Unapproved Meeting Minutes

Fairfield Planning Commission

September 4, 2024

CEDAR VALLEY INDUSTRIAL PARK
550 SOUTH 250 WEST
24-507
SITE PLAN

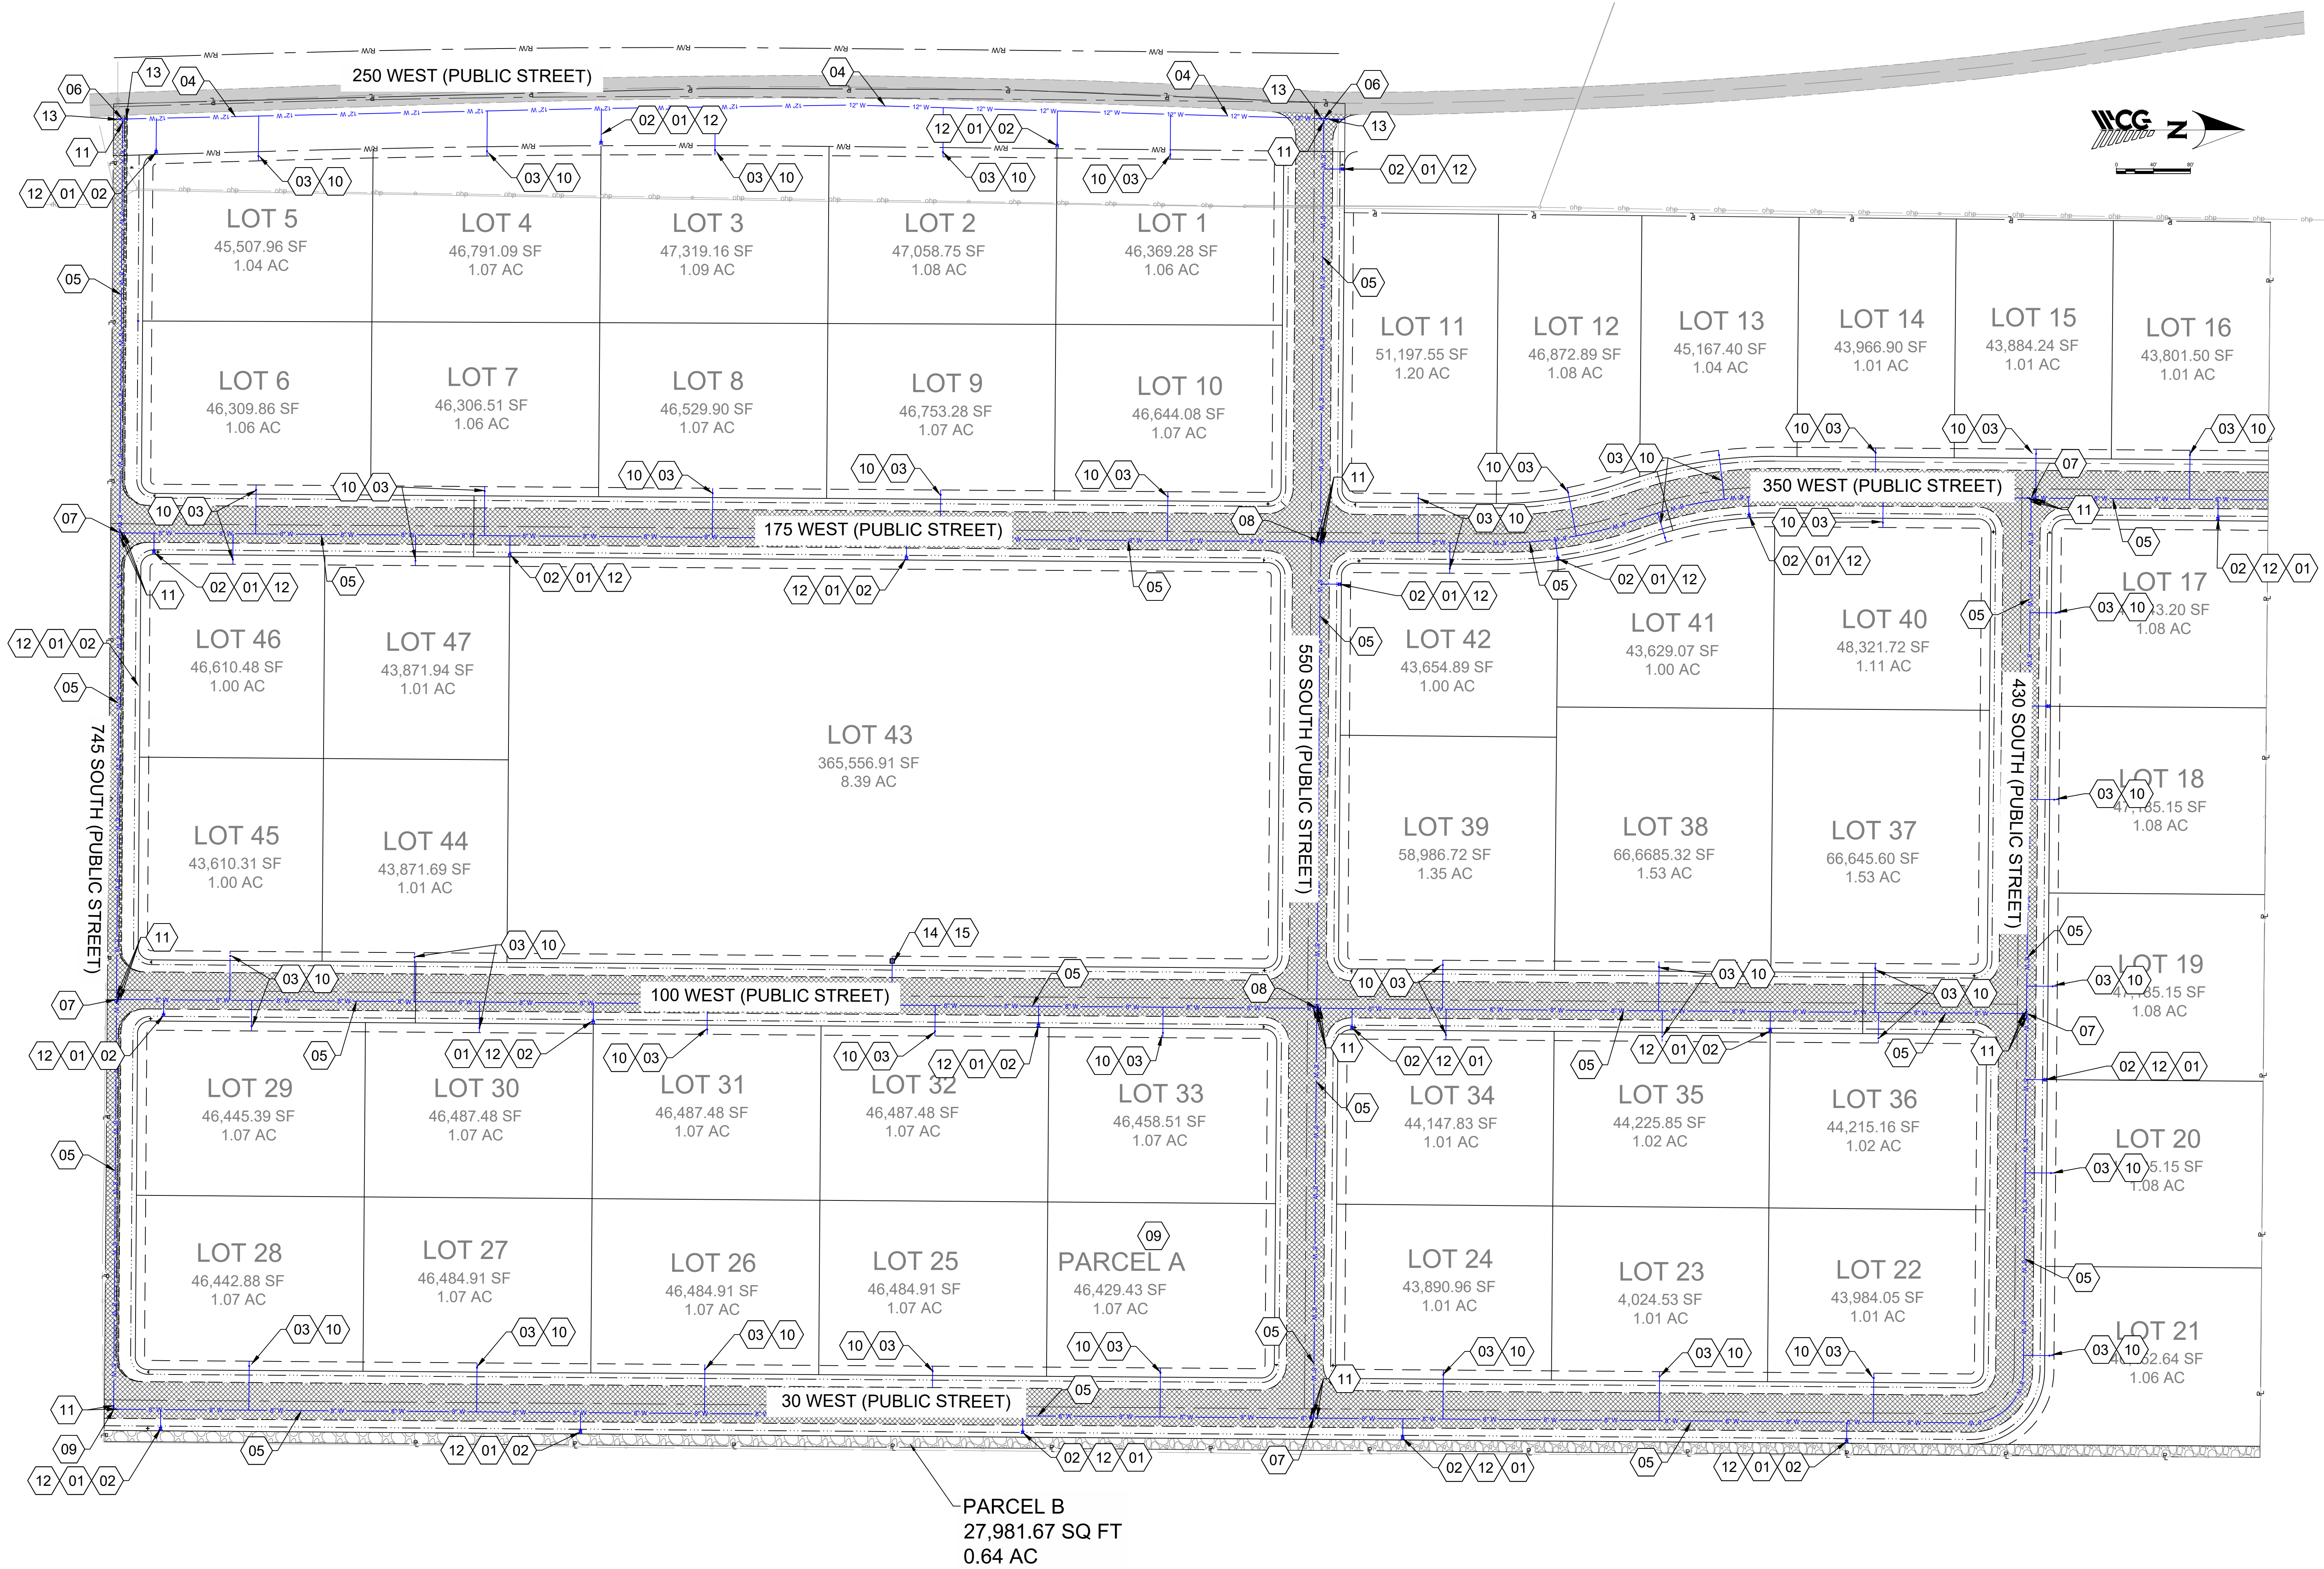
add scope notes on plan. Allen Ranch to be called out as "Heavy Duty pavement section per the geotechnical report"

250 WEST PLAN & PROFILE

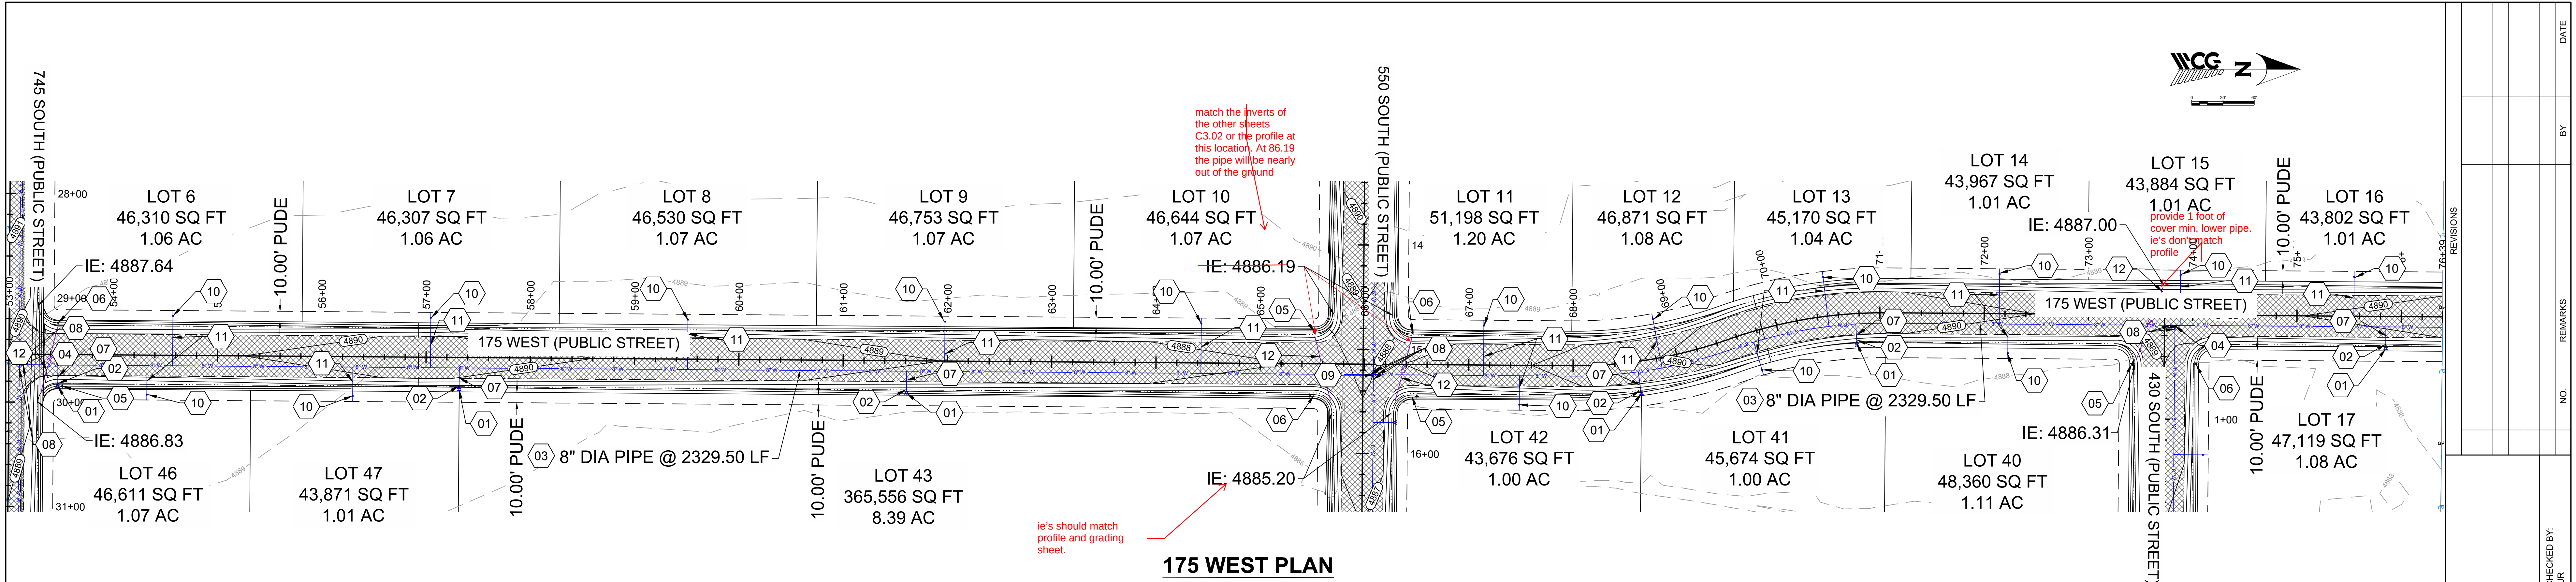
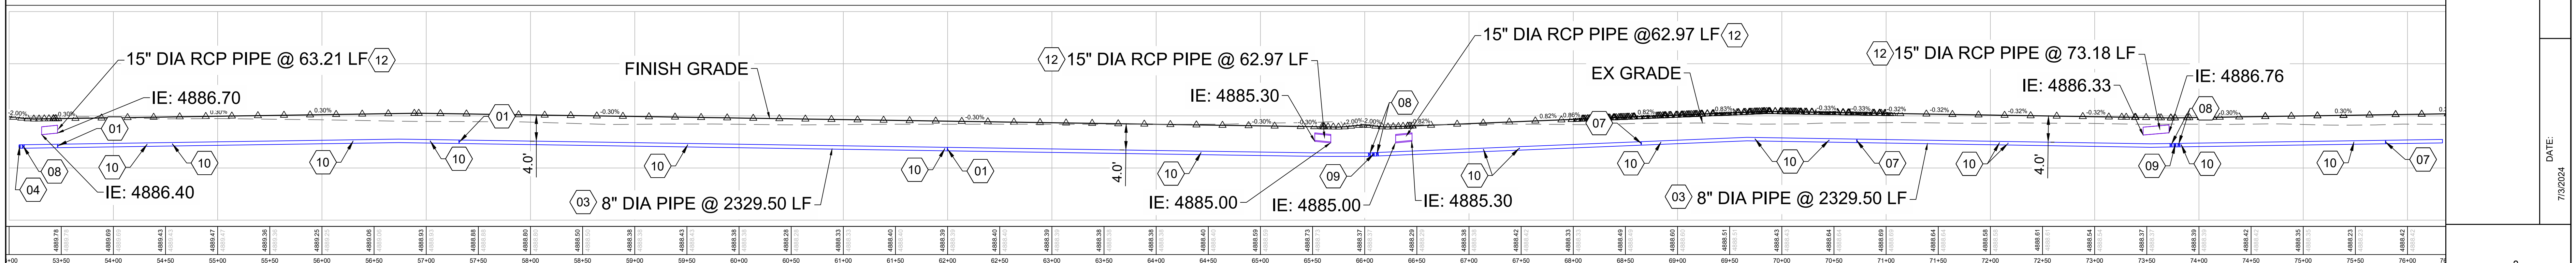
what is the plan to manage stormwater at the lowspot? a swale between lot 2 and 3 could work, be sure to include an easement on the plat if thats the route you choose
